Re: Minor Project Refinement No. 16 for the TL 6975 San Marcos to Escondido Project

TL6975 San Marcos to Escondido 69 kV Project CPUC Minor Project Refinement Form

ATTACHMENT B
MPR-16 Figure

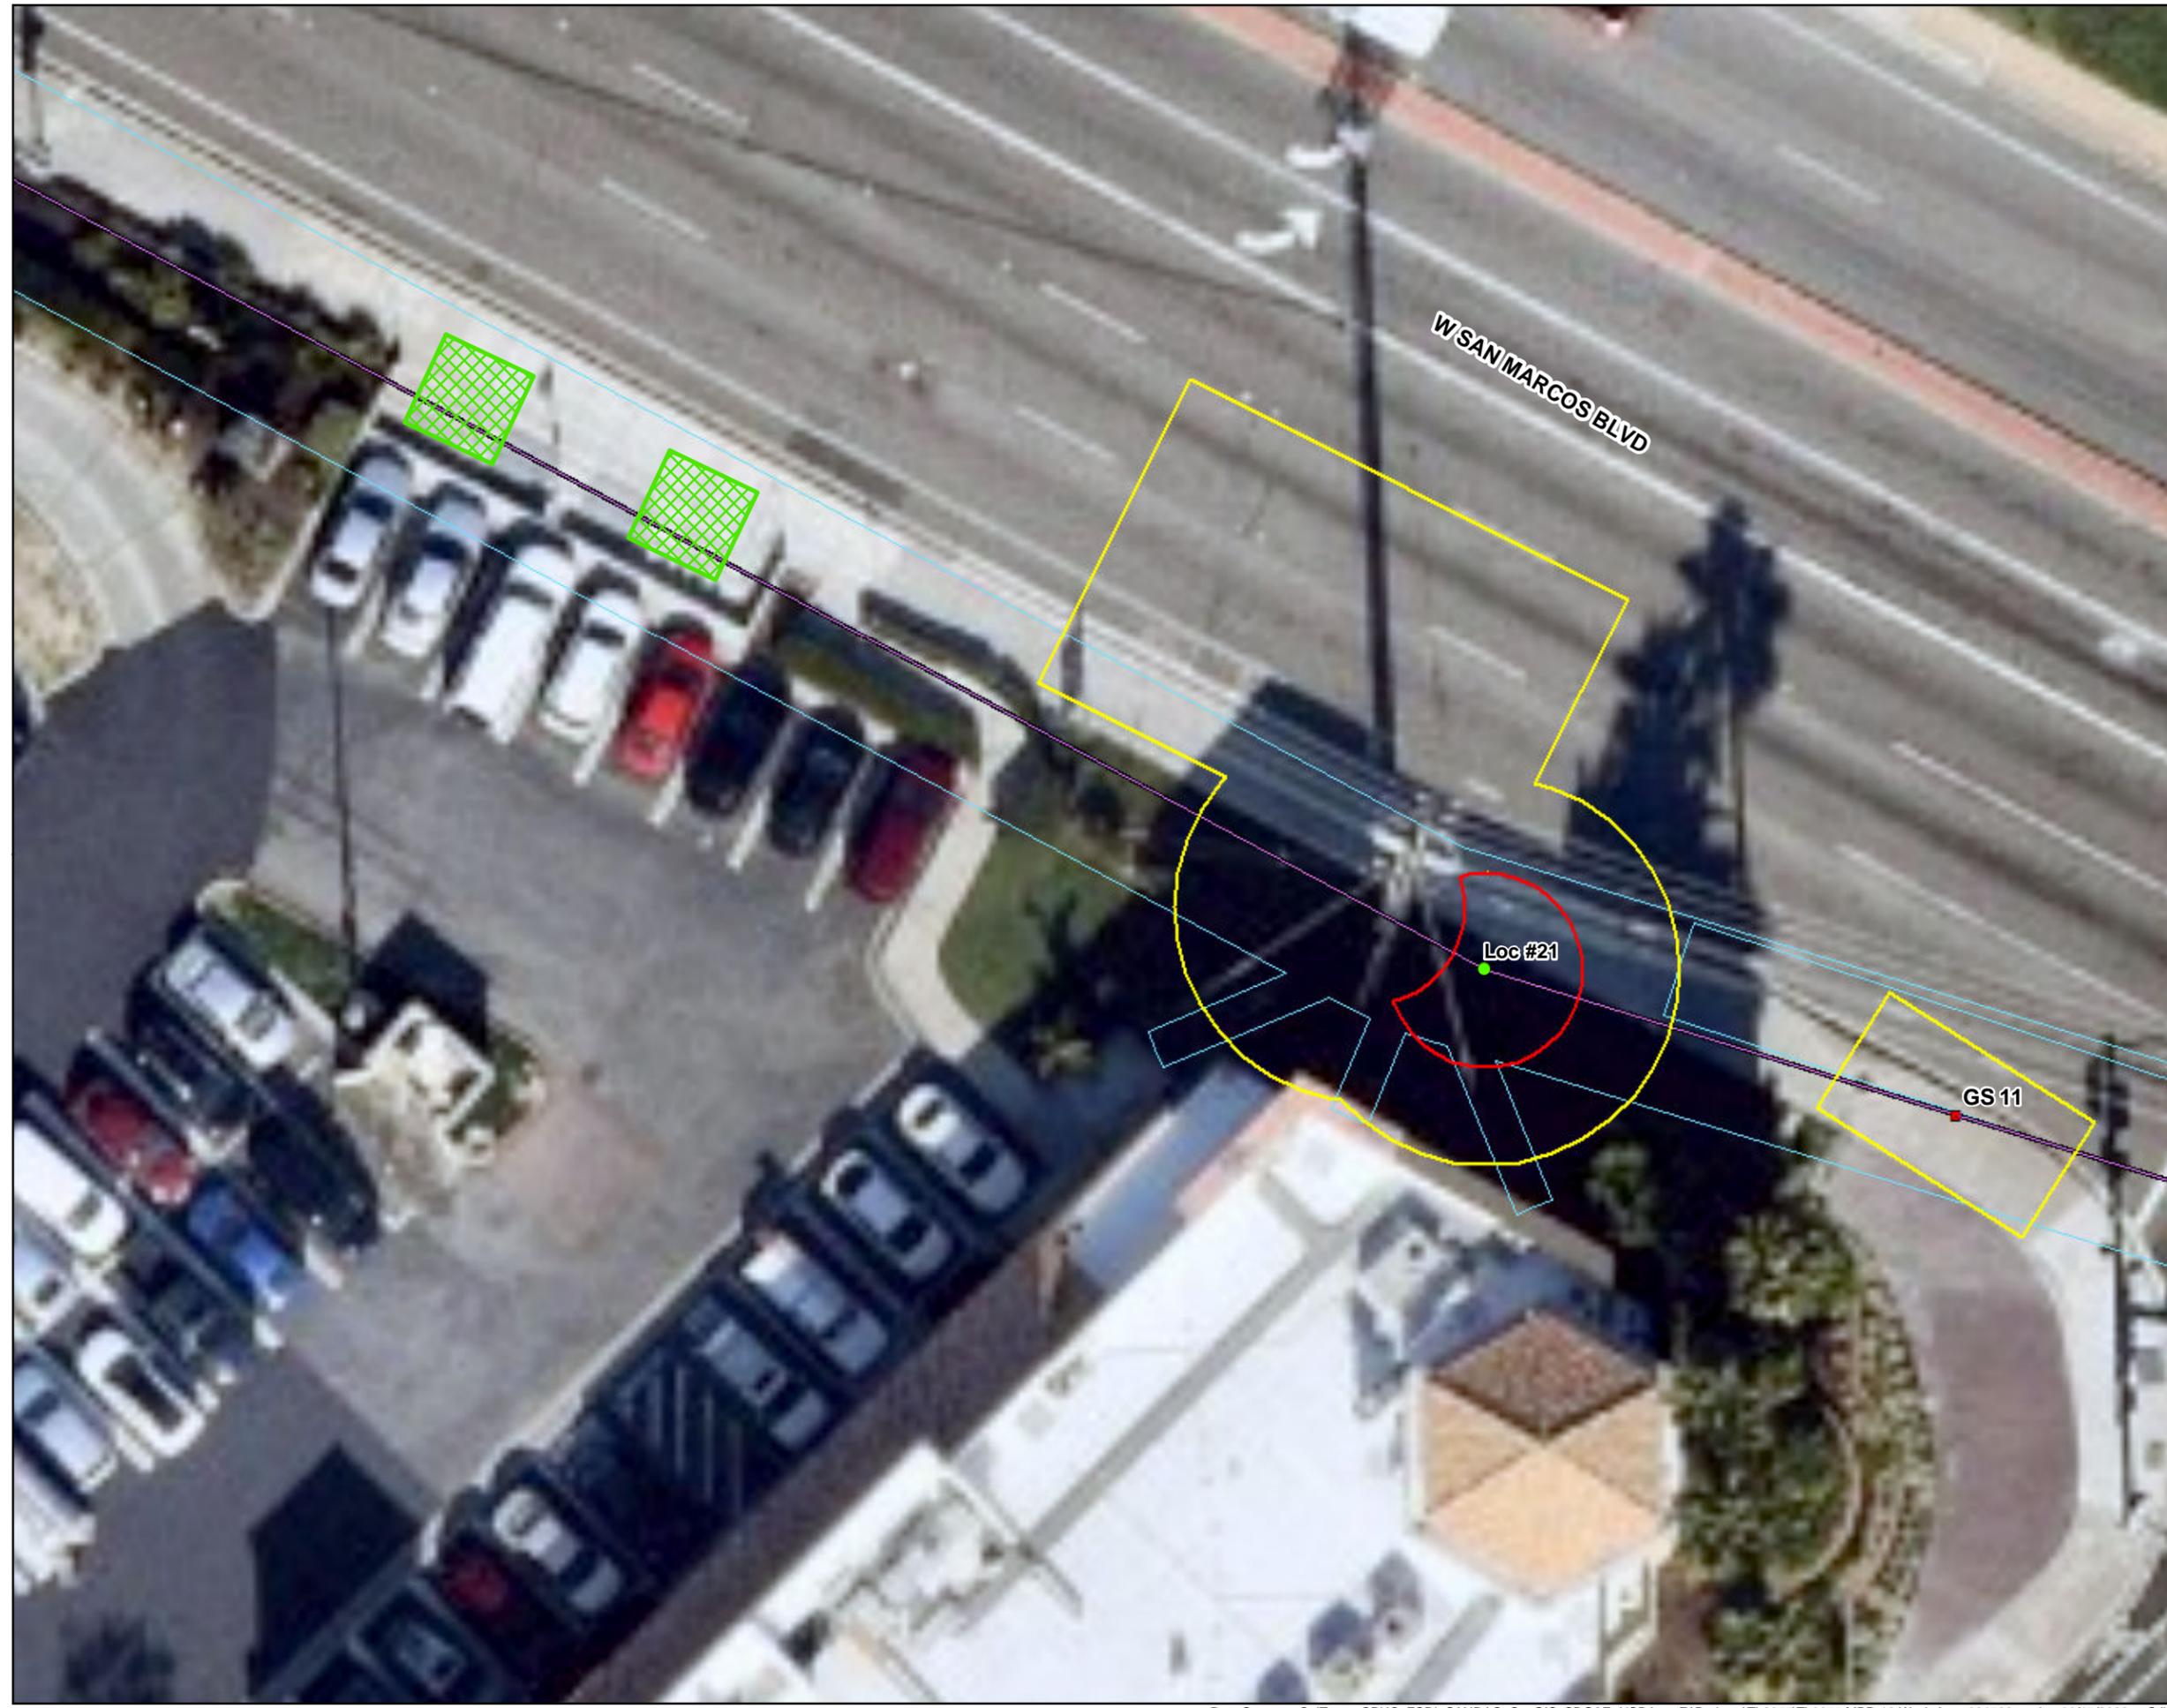
San Diego Gas and Electric (SDG&E) is requesting approval of MPR-16 to place two concrete anchor blocks per site at Locations 20 and 21 to support wire stringing activities in Segment 1 of the TL6975 San Marcos to Escondido Project (Project). See **Attachment B, MPR-16 Figure** and **Attachment C, MPR-16 Site Photographs**, for an overview of the proposed MPR-16 work areas.

SDG&E has identified two 10-foot by 10-foot work areas at Locations 20 and 21 where two 8-foot by 8-foot concrete anchor blocks would be placed per site adjacent to the approved work areas (see **Attachments B and C**). The concrete blocks have places to attach guy wire, which is then attached to the pole top (i.e., Location 20 and 21). This is necessary to stabilize the pole during wire stringing activities. With the scheduled outage being September 28, either Location 20 or Location 21 will be the end pole on a wire pull beginning at Location 8. Location 21 is preferred, but it is dependent on whether the foundation passes the strength test. If the foundation at Location 21 does not pass

The MPR-16 anchor blocks will be used to add support (through guy wires) to the tangent structure to allow for the stringing activities. Based on field review of Locations 20 and 21, it was determined that the anchor blocks would need to be placed outside of the approved work areas in the locations shown in **Attachment B, MPR-16 Figure**. Therefore, MPR-16 is required for utilization of the new anchor block work areas. Stringing conductor through this segment during the September 28 outage is critical because it represents the final construction activity required adjacent to San Marcos High School (Locations 12 – 20). Once this segment is strung, disruption of school activities will be minimal. The anchor blocks are tentatively scheduled to be placed on Monday, September 26 ahead of the stringing activities on September 28.
